Errata Sheet

March 30, 2001 / Release 1.0

Device: **SAB-C161K-LM**
 SAF-C161K-LM

Stepping Code / Marking: **ES-HA, HA**

6. Timing of flag SSCTIR (SSC Transmit Interrupt Request)

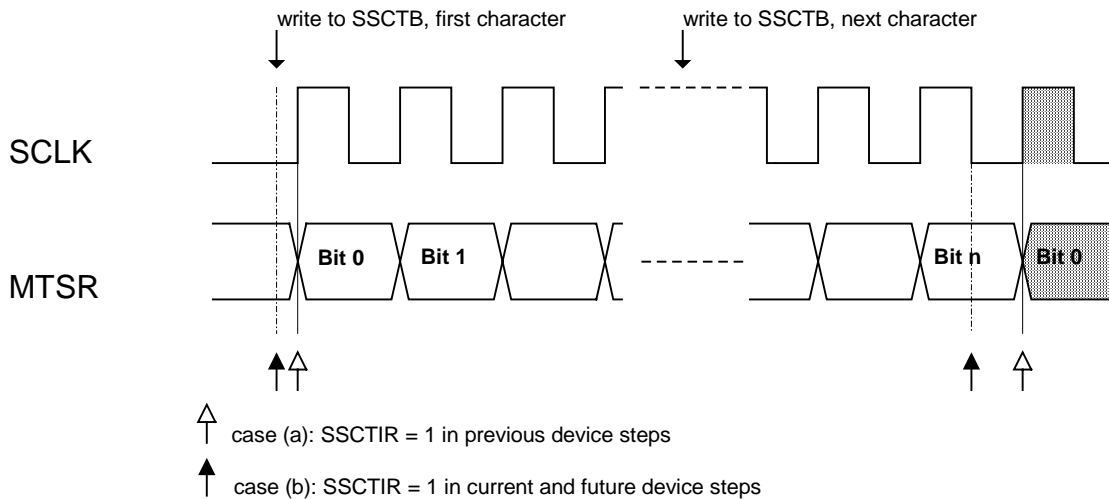
In master mode, the timing of SSCTIR depends on the device step as follows:

- (a) before step **FA** (internal stepping F11) of the **C161K**, flag SSCTIR is set to '1' synchronous to the shift clock SCLK 1/2 bit time before the first latching edge (= first shifting clock edge when SSCPH = 0). When SSCTB is written while the shift register is empty, the maximum delay between the time SSCTB has been written and flag SSCTIR=1 is up to 1/2 bit time.

- (b) beginning with step **FA** (internal stepping F12) of the **C161K**, when SSCTB has been written while the transmit shift register was empty (and the SSC is enabled), flag SSCTIR is set to '1' directly after completion of the write operation, independent of the selected baud rate. When the transmit shift register is not empty when SSCTB was written, SSCTIR is set to '1' after the last latching edge of SCLK (= 1/2 bit time before the first shifting edge of the next character). See also e.g. C167CR User's Manual V3.1, p. 12-5.

The following diagram shows these relations in an example for a data transfer in master mode with SSCPO = 0 and SSCPH = 0. It is assumed that the transmit shift register is empty at the time the first character is written to SSCTB:

Typically, in interrupt driven systems, no problems are expected from the modified timing of flag SSCTIR. However, when flag SSCTIR is polled by software in combination with other flags which are set/cleared at the end or at the beginning of a transfer (e.g. SSCBSY), the modified timing may have an effect.

In order to achieve a defined and systematic behavior with all device steps, the SSC receive interrupt, which is generated at the end of a character transmission, may be used instead of the SSC transmit interrupt.
